**Comments on the additional submission for Planning Application No 6/2018/2768/OUTLINE to build 1100 homes in Ellenbrook Fields, by Hatfield Town Council**

**Strong Objection**

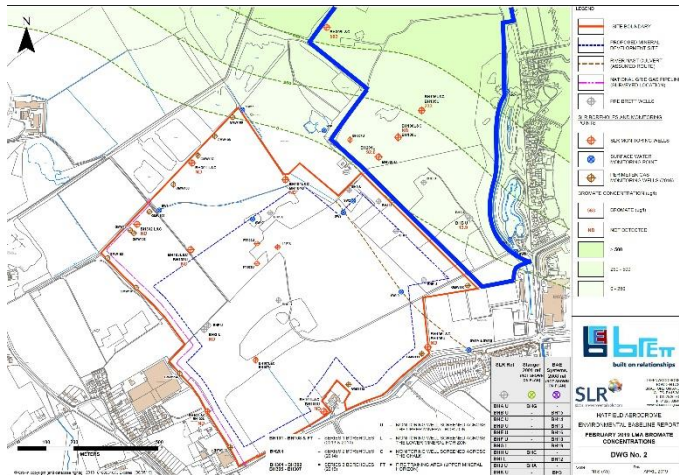
- that the interburden (clay barrier) is the only protection of the primary and secondary aquifers. The clay interburden thickness is cyclic in nature and does not give adequate protection to the underlying primary aquifer.

Our objection is that a thorough investigation of the site has not been achieved:

- Insufficient boreholes sunk to determine the depth & thickness of the interburden and the depth of chalk aquifer – only three boreholes CP001/3/2 are sunk to a depth of 6 m, 12.5 m, 14.5 m below ground level. These boreholes are of insufficient depth to monitor bromate & bromide.

Fig 1

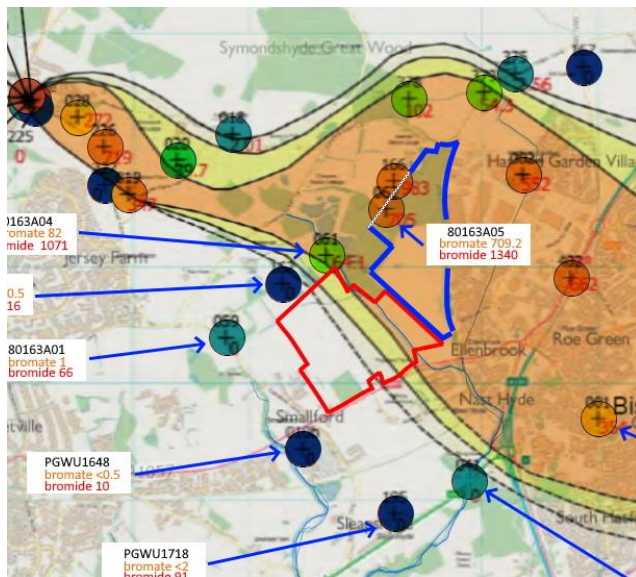
The latest plume drawing from Hatfield Quarry Application. Over 500µg/l (green) in the North where the planned housing would be:

This map was produced for the quarry application and shows the bromate contours under the housing site (dark green). The blue shows the southern part of the housing application.

EA plume drawing showing boreholes and housing applicant site. Borehole 80163A05 @ 709.2µg/l bromate is to the West of the housing site.

The EA map is expanded from Part 2A of Environmental Protection Act 1990 St Leonards Court document showing greater than 50µg/l bromate in light red. The site is in the middle of the plume. To the South is the Brett quarry application in red outline.

Fig 3

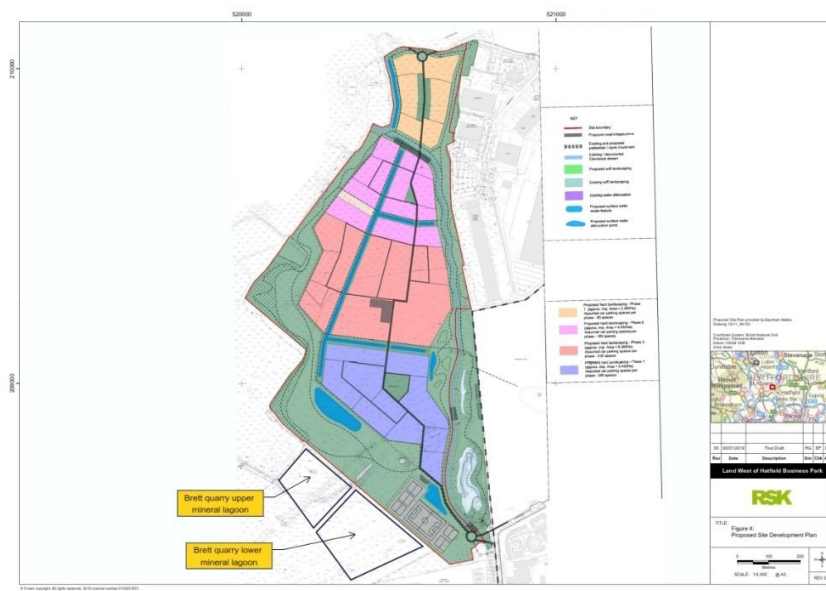
- The cumulative effect of attenuation lakes in the South and Brett quarry infiltration lagoons in the same area was not taken into consideration Fig 3.

Fig 3 shows proposed Brett quarry lagoons in the South. The expected infiltration rate of the Upper Mineral Horizon is estimated at 1,100 to 2,300 cubic metres/day directly into the same ground that the attenuations ponds (blue) would add another 1000 to 2500 cubic metres/day, from the run off from the new development.

These totals double the groundwater amount, which is now focused on a specific area potentially leading to flooding downstream of the combined sites.

Fig 4

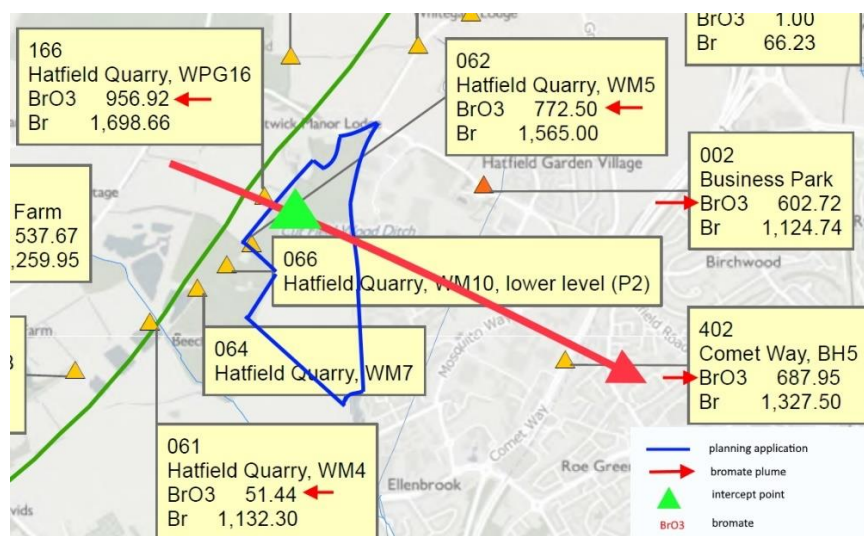
- The objection is that the EA remedial plan using an array of boreholes, perpendicular to the plume and at its highest bromate levels, would require an area to operate that is clear of obstacles and housing.

The intercept point is shown in green. The plume has a S.E direction.
